V2500-A1/A5 SERIES PROPULSION SYSTEM NON-MODIFICATION SERVICE BULLETIN

This document transmits the Initial Issue of Non-Modification Service Bulletin
V2500-NAC-71-0305

NON-MODIFICATION SERVICE BULLETIN – NACELLE – FORWARD ENGINE MOUNT – BOLT PART
NUMBER, INSPECTION OF

Forward Engine Mount Assembly
Figure 1

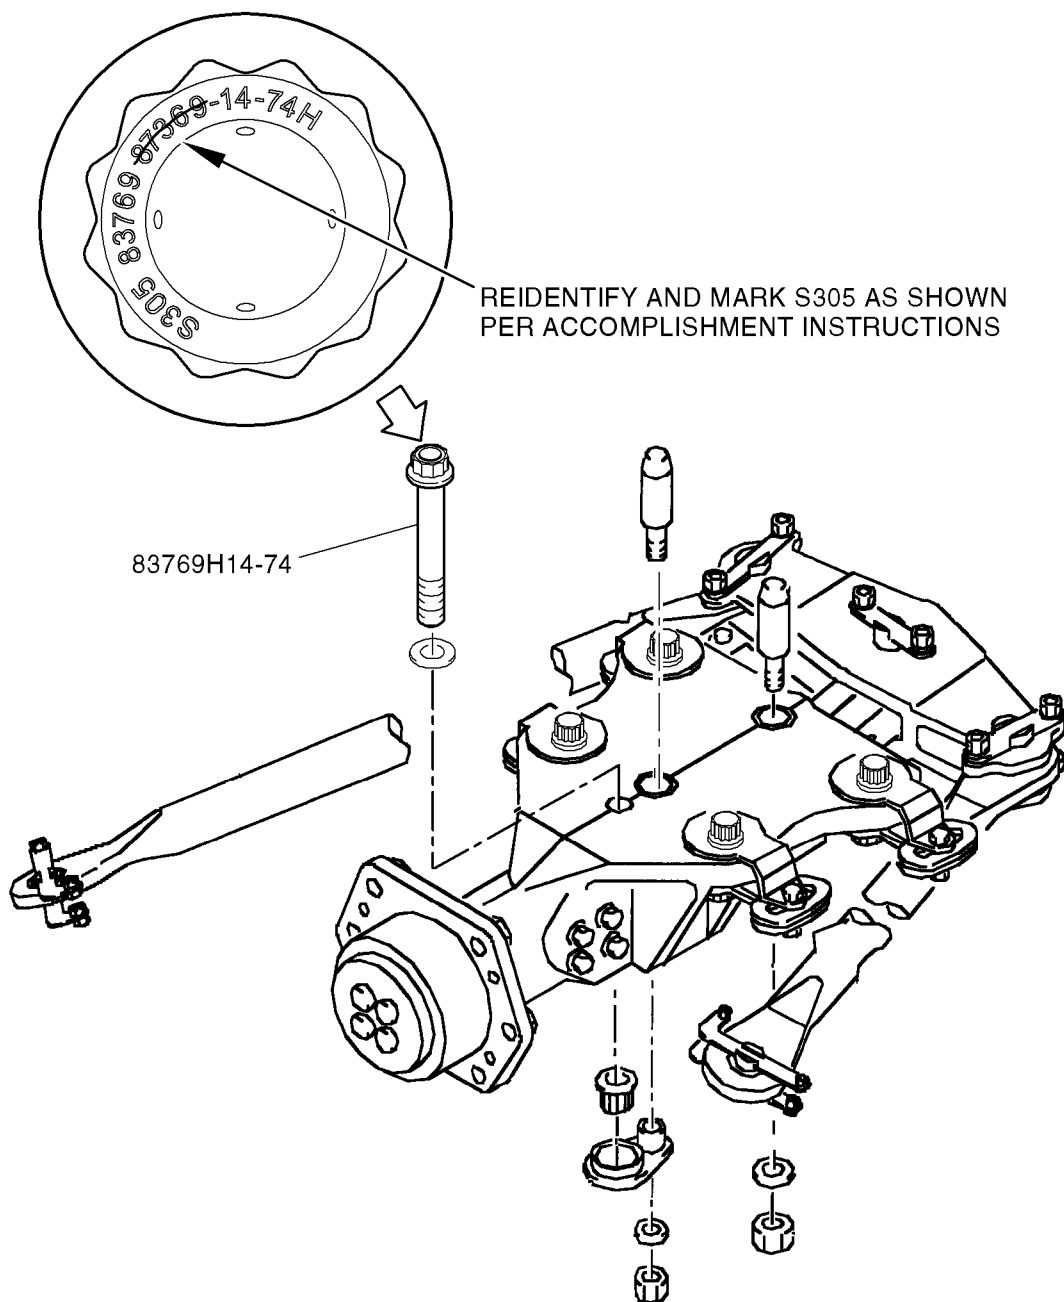
The supplier for the engine mount bolt in question inadvertently transposed two digits of the part number. The error is limited to a lot of 27 bolts and is the only deviation from the part specification.

- (1) Refer to Figure 1 to locate affected bolts.
 - (2) Inspect the bolts per CMM 71-21-12-200-001 item 12.
 - (3) Refer to Table 1 to confirm any action required based on the part number stamped on the bolt head.

- (4) To correct a bolt with transposed numbers, electroetch the correct basic part number "83769-" immediately preceding the existing incorrect "87369" number. Use the electroetch to cross out the existing "87369" on the bolt head. Mark bolt head at a depth of 0.010 in max. Refer to IAE V2500 Standard Practices/Processes Manual, Chapter 70-09-00. See Figure 1 for clarification.

- (5) Add the "H" designator immediately subsequent to the existing part number. Mark bolt head at a depth of 0.010 in max. Refer to the IAE V2500 Standard Practices/Processes Manual, Chapter 70-09-00. See Figure 1 for clarification.

- (6) To mark that Service Bulletin 71-0305 has been accomplished, electroetch "S305" on the bolt head. Mark bolt head at a depth of 0.010 in max. Refer to the IAE V2500 Standard Practices/Processes Manual, Chapter 70-09-00.

CAUTION: DO NOT USE METAL STAMP OR VIBROETCH ON ENGINE MOUNT BOLTS.
